Application No: 2023/4757/P

Address:	Utopia Village 7 Chalcot Road London NW1 8LH		4
Application Number(s):	2023/4757/P	Officer: Ewan Campbell	
Ward:	Primrose Hill		
Date Received:	07/11/2023

Proposal: Demolition of existing lean-to structures along the eastern boundary, erection of infill extension, alterations to the exterior of the building including replacement/alteration of windows and doors, removal of external services and plant, improvement of some external finishes, replacement of sections of roof, recladding of external stair case, installation of vents and over-cladding to plant room, refurbishment of bridge structure, installation of air intake/exhaust features associated with ventilation/heating/cooling systems, external courtyard landscaping works and replacement of entrance gates.

OFFICERS' REPORT

Figure 2 – CGI of the new plant building

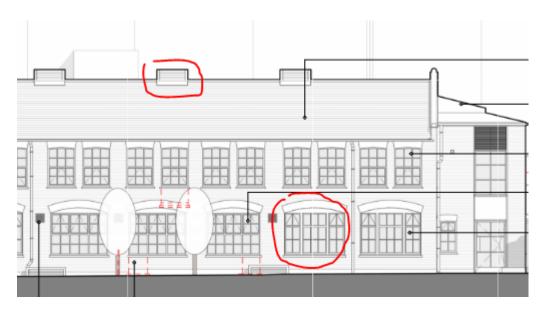
The design of the plant room has since been revised to appear like a more like the existing building and the other works are small in scale and nature. Please refer to section 7 (Design and Conservation) for full assessment.

- 7.15 At the southern end of the historic buildings it is proposed to replace a modern two storey building with a large plant enclosure which will appear similar to the existing building in terms of scale and fenestration. The existing building is a rather bland 1950s structure with plain brickwork and strips of fenestration. Other than its scale and use of brickwork, it contributes little to the composition of Utopia Village. Whilst the refurbishment works mean it is similar in design and scale the finishes and materials are of higher quality and visually cleaner meaning that the replacement building is acceptable and preserves the character of the site and conservation area.

Diagram Showing Considered Plant Locations

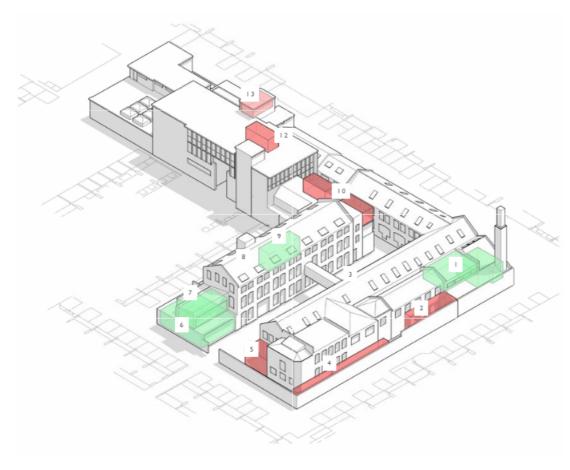
- iii. The proposal also includes a total refurbishment and alteration to the plant equipment and energy system. This includes new air source heat pumps and air condensers proposed within a new plant building, internally housed within the building adjacent to Edis Street and more plant set behind the boundary wall adjacent to the rear of properties on Egbert Street. The proposal has been supported by noise assessments which demonstrate the noise levels to be of acceptable, in compliance with policy thresholds and therefore the impact on amenity would not be considered to be harmful. Objections have been submitted to the proposal and these mainly relate to concerns around noise issues. Independent noise reports have been commissioned by objectors to support the objections. The Council's Environmental Health team has reviewed these reports as well and has still concluded that the noise from the proposed plant and equipment does not exceed the required thresholds.

- 8.3 The proposal includes the refurbishment of an existing building to the south of the site which will house the majority of the site's plant equipment and therefore has noise implications which need to be fully considered. This is one of the key issues which has been raised in the objections from residents who have also providing their own noise assessment for review and consideration.
